PR/0269/23

Record of Executive Business and Chief Executive's Order

Reg. Reference: SD22A/0404 **Application Date:** 26-Oct-2022
Submission Type: Additional **Registration Date:** 16-Feb-2023
Information

Location: Templeogue College, Templeville Road, Dublin 6.

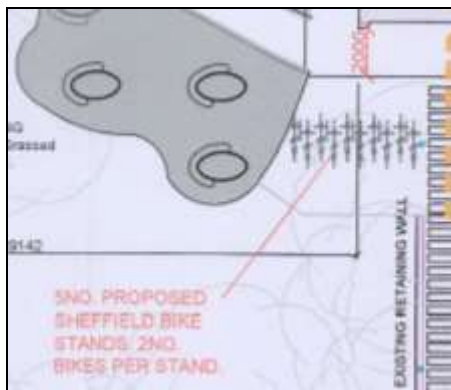
1.4. *The applicant is requested to submit details on the number of staff pupils at the school. The applicant should refer to Table 12.25: Maximum Parking Rates (Non-Residential) – from the SDCC County Development Plan 2022-2026 and demonstrate an adequate provision of parking spaces required for staff and students at the school.*
